#### **D) AMENDMENTS TO THE DRAWINGS**

### **REMARKS**

This is a Response to the Office Action dated June 30, 2005. Upon entry of this Response, Claims 11-35 and 42-43 will be pending in this Application.

added FIGURE 14A

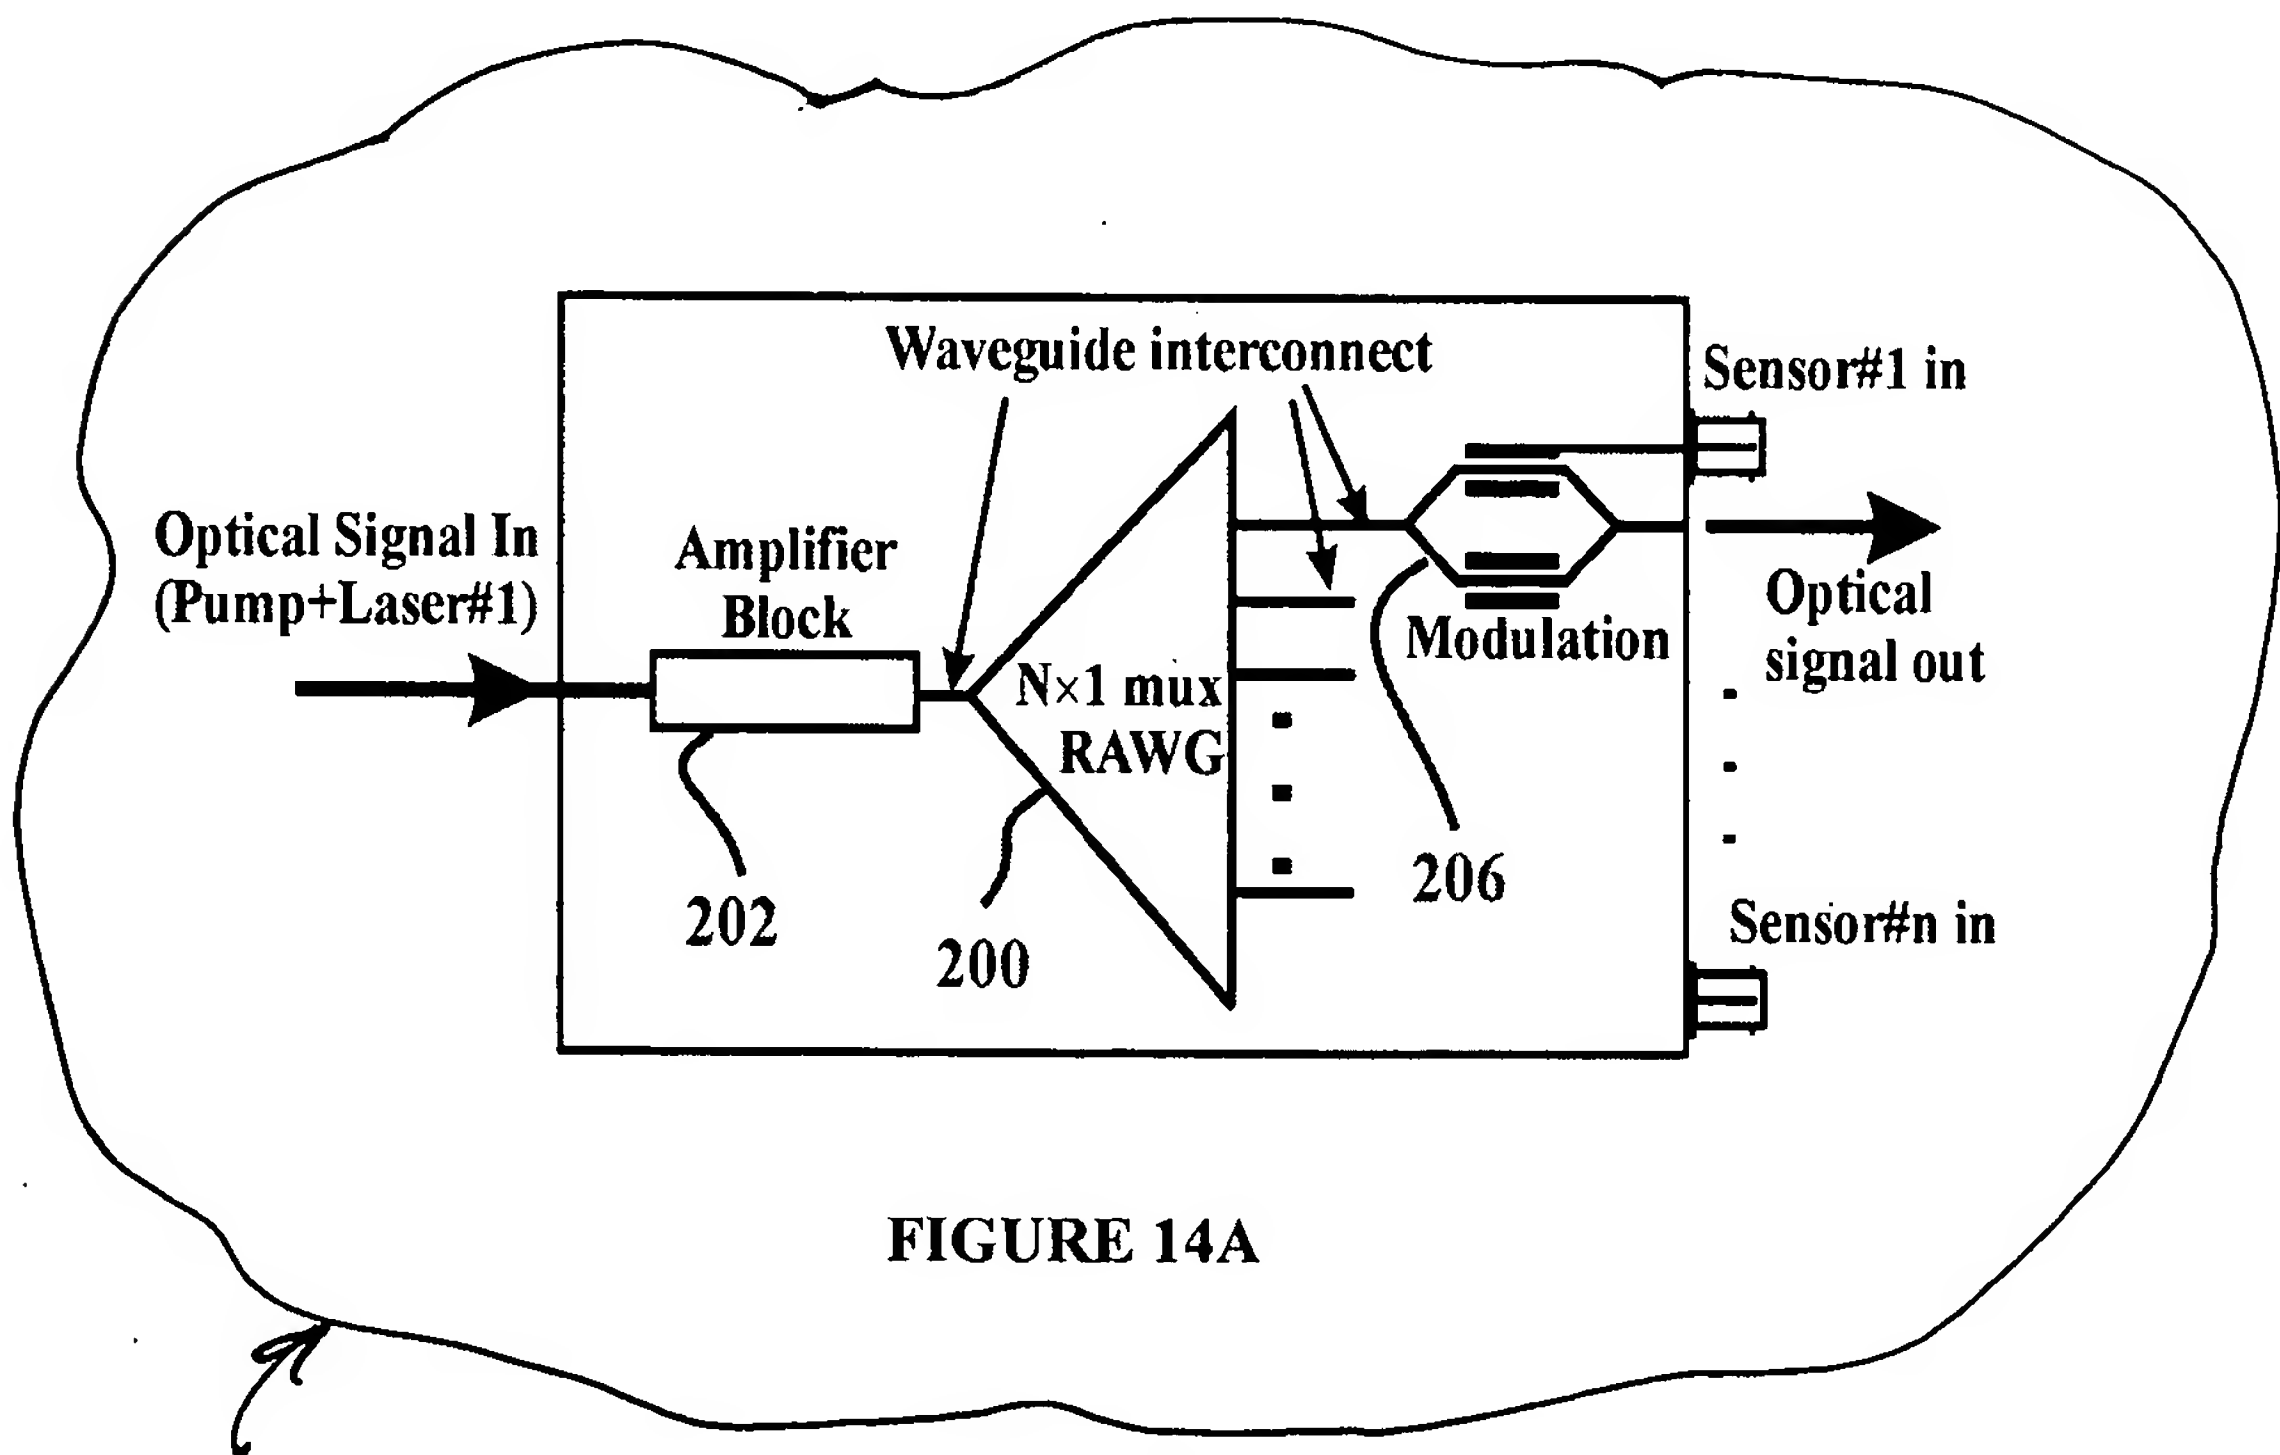
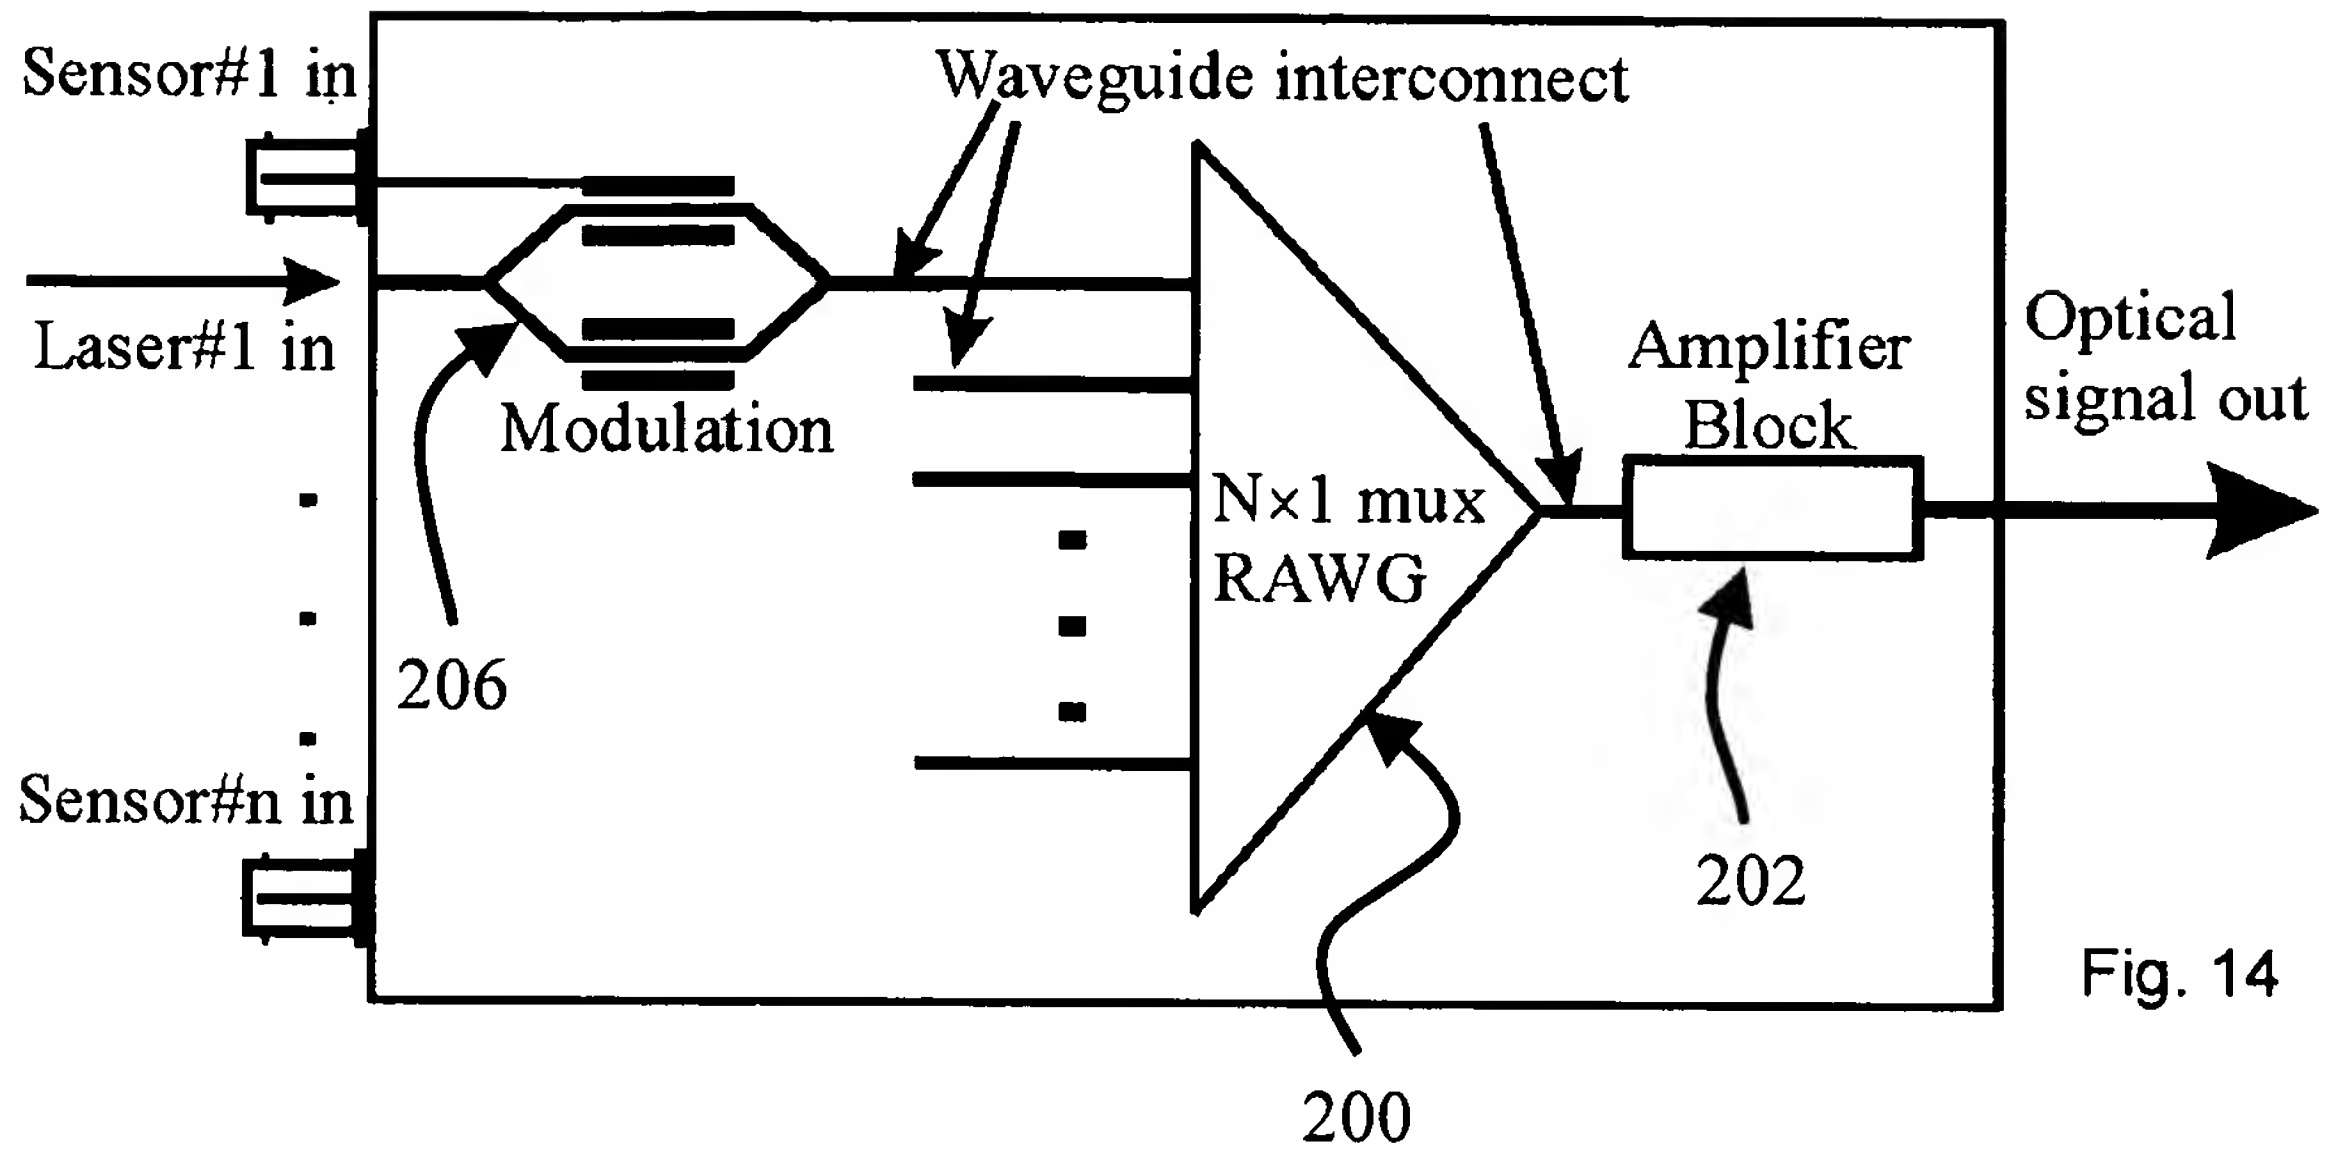
The Examiner stated that the modulator for electro-optically processing output signals, as claimed in claim 28, which depends on claim 27, must be shown or the feature(s) canceled from the claim(s).

Applicant has attached a Replacement Sheet and an Annotated Marked-up Drawing, including proposed new Figure 14A, and Figure 14.

A proposed new Figure 14A is attached hereto, which is essentially the same device as shown in Figure 14. Figure 14A shows the device with the input signal into the Amplifier Block, and the output from the modulators 206. There is no difference in both Figures, it is simply a matter of which interface is selected as the input.
